Contract #: 04-0120F4Cty: SF/ALA Rte: 80 PM: 13.2/13.9File #: 69.25B**QUALITY ASSURANCE -- NON-CONFORMANCE REPORT****Location:** Changxing Island, Shanghai, P.R. China**Report No:** NCR-000631**Prime Contractor:** American Bridge/Fluor Enterprises, a JV**Date:** 13-Jan-2010**Submitting Contractor:** Zhenhua Port Machinery Company, Ltd (ZPMC), Changxing Island**NCR #:** ZPMC-0604**Type of problem:**

**Reference Description:** Missed Longitudinal and Transverse MT Linear Indications by QC in Segment 8CW LD and FB

# QUALITY ASSURANCE -- NON-CONFORMANCE REPORT

**Subject:** NCR No. ZPMC-0604

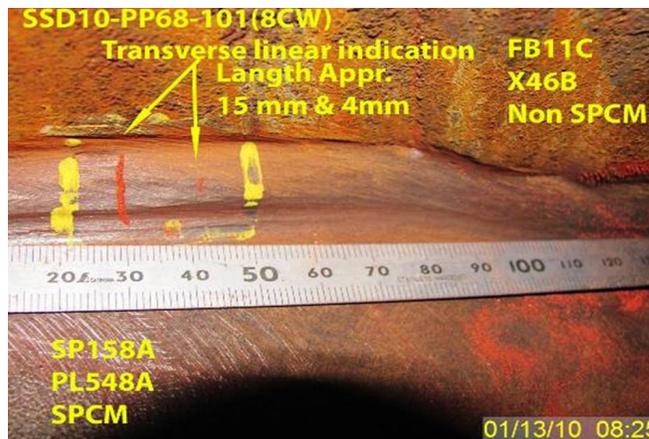
During the Quality Assurance (QA) Magnetic Particle Testing (MT) review of welds located on Segment 8CW, this QA Inspector discovered the following linear indications:

-Weld #SSD10-PP68-101 (SPCM): Two (2) Transverse linear indications measuring approximately 15mm and 4mm. Members are identified as FB11C (X46B) Non SPCM to SP158A (PL548A) SPCM.

-Weld #SEG047F-002 (SPCM): One (1) Longitudinal linear indication measuring approximately 15 mm. Members are identified as FB19B (X49F) SPCM to LD4 (X75G) Non SPCM.

-Weld #SEG047F-014 (non SPCM): One (1) Transverse linear indication measuring approximately 15 mm. Members are identified as LD4 (X75G) Non SPCM to FB19B (X7M) Non SPCM.

-Weld #SP447A-063 (SPCM): One (1) Transverse linear indication measuring approximately 8 mm. Members are identified as FB19B (X12C) SPCM to Side Plate 'I' Stiffener (RS91GB) Non SPCM.

-Weld #SSD10A-PP68-144 (SPCM): One (1) Longitudinal linear indication measuring approximately 13 mm. Members are identified as FB19B (X12C) SPCM to Deck Plate 'I' Stiffener (RS62GA) Non SPCM.

-Weld Connecting Drip plate to Floor Beam (FB27A) at Panel Point PP70 (Cross Beam Side) (SPCM): One (1) Transverse linear indication measuring approximately 17 mm. Members are identified as Drip plate (329M) Non SPCM to Floor Beam FB27A (X12D) Seismic Performance Critical Material (SPCM). This weld does not appear to be identified by number on the contractors weld maps.

-All indications are clearly marked on the material near the weld. For details, see Magnetic particle Testing (MT) report generated by this QA for this date.

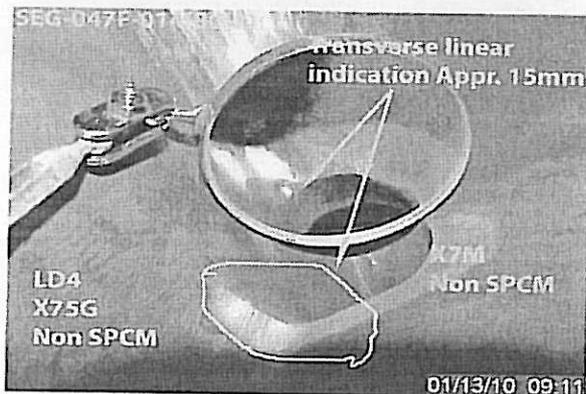
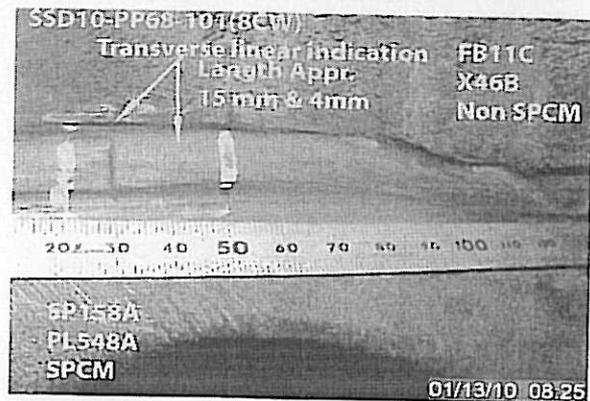
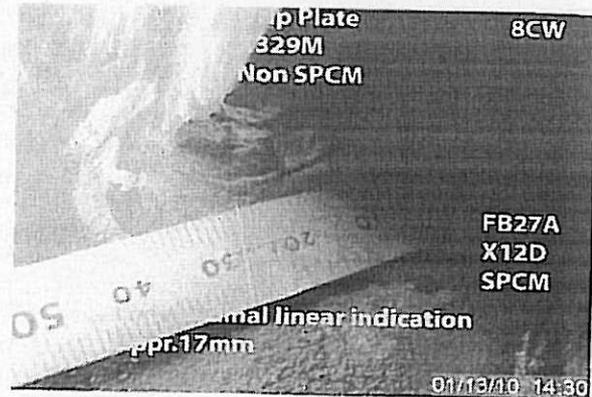
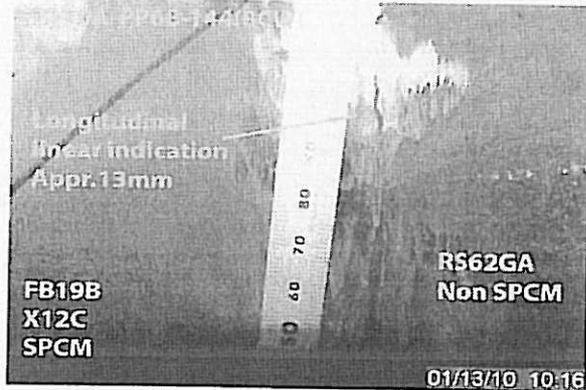
During the Quality Assurance (QA) Magnetic Particle Testing (MT) review of welds located on Segment 8CW, this QA Inspector discovered the following linear indications:

- Weld #SSD10-PP68-101 (SPCM): Two (2) Transverse linear indications measuring approximately 15mm and 4mm. Members are identified as FB11C (X46B) Non SPCM to SP158A (PL548A) SPCM.

- Weld #SEG047F-002 (SPCM): One (1) Longitudinal linear indication measuring approximately 15 mm. Members are identified as FB19B (X49F) SPCM to LD4 (X75G) Non SPCM.

- Weld #SEG047F-014 (non SPCM): One (1) Transverse linear indication measuring approximately 15 mm. Members are identified as LD4 (X75G) Non SPCM to FB19B (X7M) Non SPCM.

- Weld #SP447A-063 (SPCM): One (1) Transverse linear indication measuring approximately 8 mm. Members are identified as FB19B (X12C) SPCM to Side Plate 'I' Stiffener (RS91GB) Non SPCM.

- Weld #SSD10A-PP68-144 (SPCM): One (1) Longitudinal linear indication measuring approximately 13 mm. Members are identified as FB19B (X12C) SPCM to Deck Plate 'I' Stiffener (RS62GA) Non SPCM.

- Weld Connecting Drip plate to Floor Beam (FB27A) at Panel Point PP70 (Cross Beam Side) (SPCM): One (1) Transverse linear indication measuring approximately 17 mm. Members are identified as Drip plate (329M) Non SPCM to Floor Beam FB27A (X12D) Seismic Performance Critical Material (SPCM). This weld does not appear to be identified by number on the contractors weld maps.

-All indications are clearly marked on the material near the weld. For details, see Magnetic particle Testing (MT) report generated by this QA for this date.

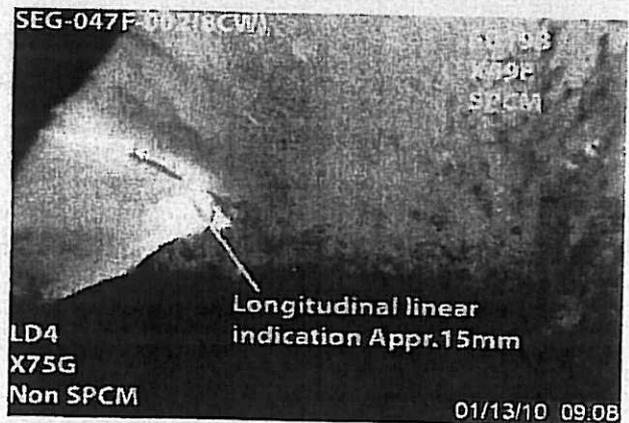
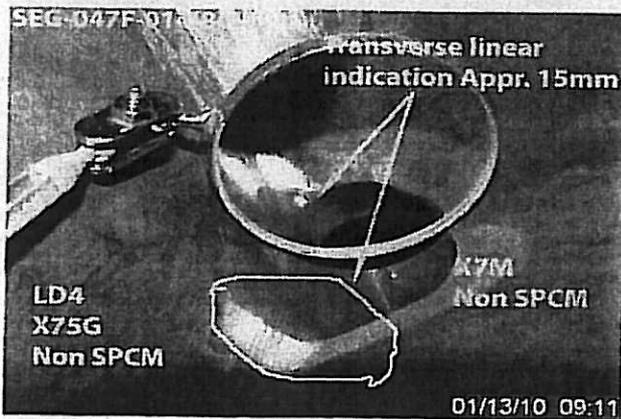
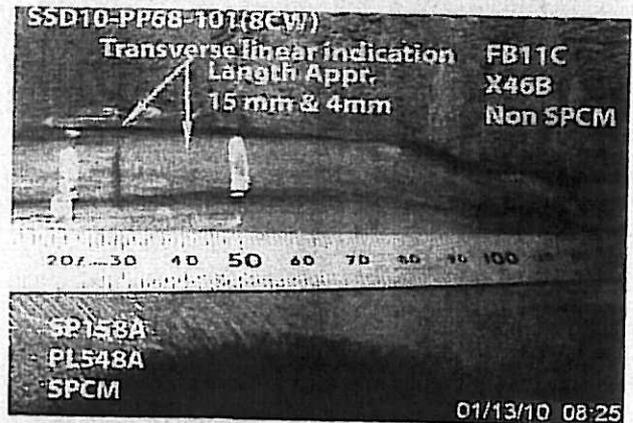
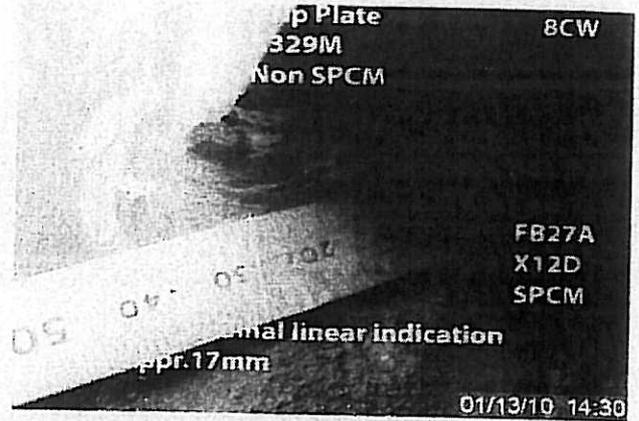
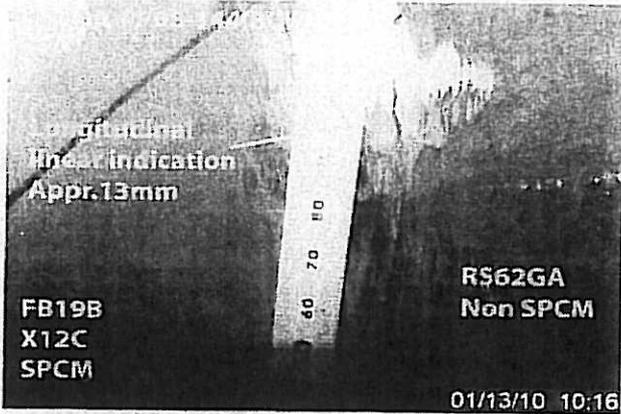
During the Quality Assurance (QA) Magnetic Particle Testing (MT) review of welds located on Segment 8CW, this QA Inspector discovered the following linear indications:

-Weld #SSD10-PP68-101 (SPCM): Two (2) Transverse linear indications measuring approximately 15mm and 4mm. Members are identified as FB11C (X46B) Non SPCM to SP158A (PL548A) SPCM.

-Weld #SEG047F-002 (SPCM): One (1) Longitudinal linear indication measuring approximately 15 mm. Members are identified as FB19B (X49F) SPCM to LD4 (X75G) Non SPCM.

-Weld #SEG047F-014 (non SPCM): One (1) Transverse linear indication measuring approximately 15 mm. Members are identified as LD4 (X75G) Non SPCM to FB19B (X7M) Non SPCM.

-Weld #SP447A-063 (SPCM): One (1) Transverse linear indication measuring approximately 8 mm. Members are identified as FB19B (X12C) SPCM to Side Plate 'I' Stiffener (RS91GB) Non SPCM.

-Weld #SSD10A-PP68-144 (SPCM): One (1) Longitudinal linear indication measuring approximately 13 mm. Members are identified as FB19B (X12C) SPCM to Deck Plate 'I' Stiffener (RS62GA) Non SPCM.

-Weld Connecting Drip plate to Floor Beam (FB27A) at Panel Point PP70 (Cross Beam Side) (SPCM): One (1) Transverse linear indication measuring approximately 17 mm. Members are identified as Drip plate (329M) Non SPCM to Floor Beam FB27A (X12D) Seismic Performance Critical Material (SPCM). This weld does not appear to be identified by number on the contractors weld maps.

-All indications are clearly marked on the material near the weld. For details, see Magnetic particle Testing (MT) report generated by this QA for this date.
